Title of Change:	To update the package dimension to case outline 418BK on datasheet of RUR1S1560S9A	
Effective date:	12 Oct 2021	
Contact information:	Contact your local onsemi Sales Office or Charles.Jiang@onsemi.com	
Type of notification:	This Product Bulletin is for notification purposes only. onsemi will proceed with implementation of this change upon publication of this Product Bulletin.	
Change Category:	To correct the case outline on datasheet	
Change Sub-Category(s):	Datasheet/Product Doc change	
Sites Affected:		
onsemi Sites	External Foundry/Subcon Sites	
None	None

This product bulletin is released to reflect the correct case outline from 418AJ to 418BK for RUR1S1560S9A, due to an unforeseen error found in the datasheet.

Figure 9. TO-263 2L (D²-PAK) - 2LD, TO263, SURFACE MOUNT

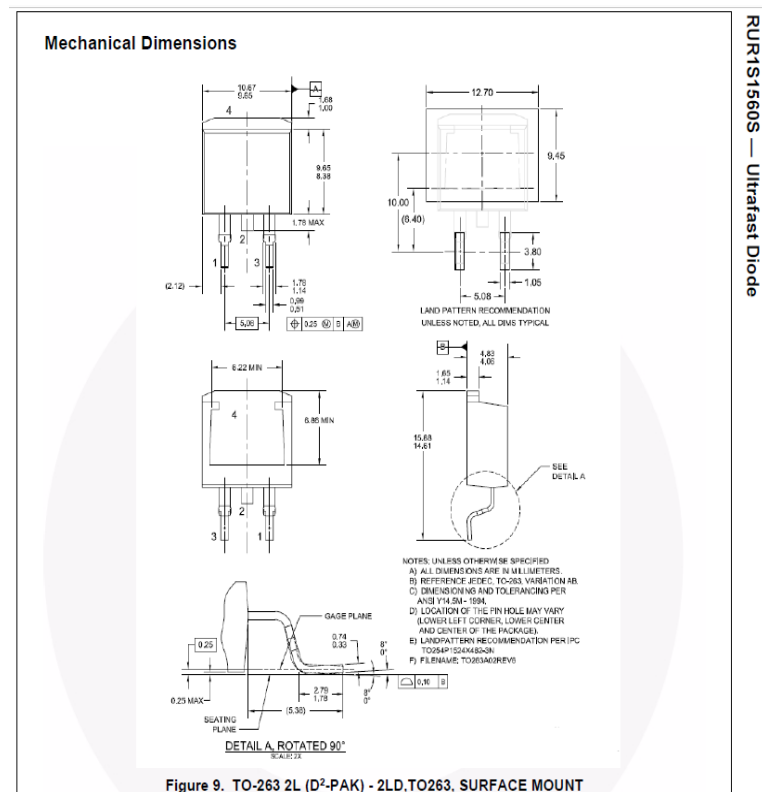
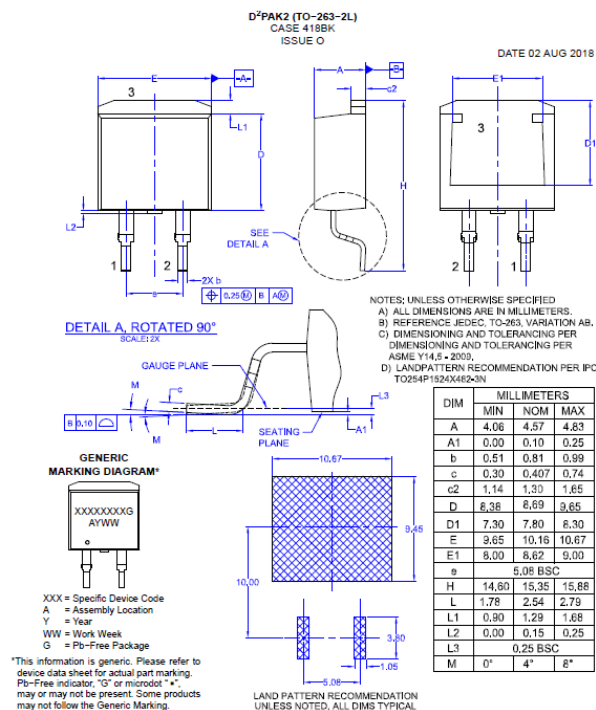
Before:

After:

MECHANICAL CASE OUTLINE
